<b>Well Name:</b> QUANDRY BJQ FEDERAL COM	<b>Well Location:</b> T21S / R24E / SEC 10 / NENW /	<b>County or Parish/State:</b> EDDY / NM
<b>Well Number:</b> 1	<b>Type of Well:</b> CONVENTIONAL GAS WELL	<b>Allottee or Tribe Name:</b>
<b>Lease Number:</b> NMNM022534A	<b>Unit or CA Name:</b> BAMBOOZLED BBX FED COM 2	<b>Unit or CA Number:</b> NMNM114185
<b>US Well Number:</b> 300153584800S1	<b>Well Status:</b> Producing Gas Well	<b>Operator:</b> EOG RESOURCES INCORPORATED

Notice of Intent

<b>Type of Submission:</b> Notice of Intent	<b>Type of Action</b> Plug and Abandonment
<b>Date Sundry Submitted:</b> 05/27/2021	<b>Time Sundry Submitted:</b> 09:14
<b>Date proposed operation will begin:</b> 06/14/2021	
<b>Procedure Description:</b> Please see attached.

EOG Resources, Inc. plans to plug and abandon this well as follows:

A12: 30-015-35848

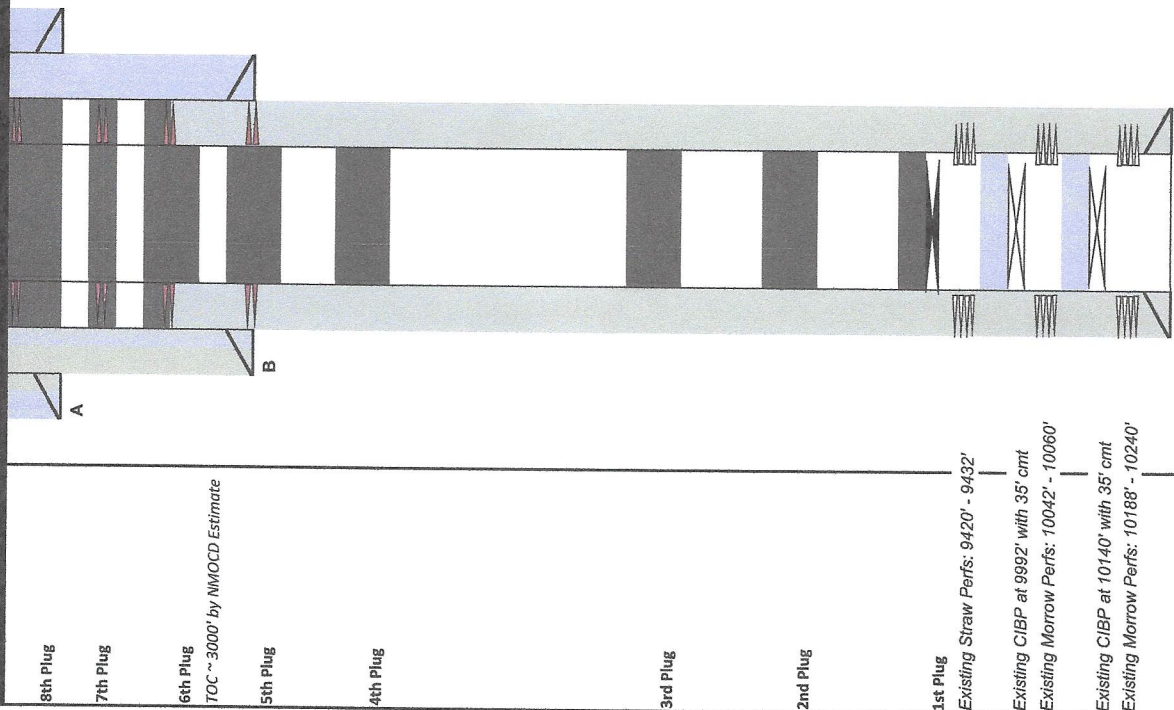
5. Spot a 25 sx Class C cement plug from 4076 ft – 3824 ft. This will cover the 3000 ft spacing limit in cased hole.
6. Perforate at 3746 ft. Spot a ~~25~~ <sup>30 sx</sup> sx Class C cement plug from 3746 ft – ~~3494~~ <sup>3484'</sup> ft. WOC and tag. This will cover intermediate casing shoe and Bone Spring top

9. Perforate at ~~250~~ <sup>475</sup> ft. Spot a ~~76~~ <sup>150 sx</sup> sx Class C cement plug from ~~250~~ <sup>475'</sup> ft up to surface. WOC and tag. *(In/Out)*  
Back fill as needed. *Verify @ surface*
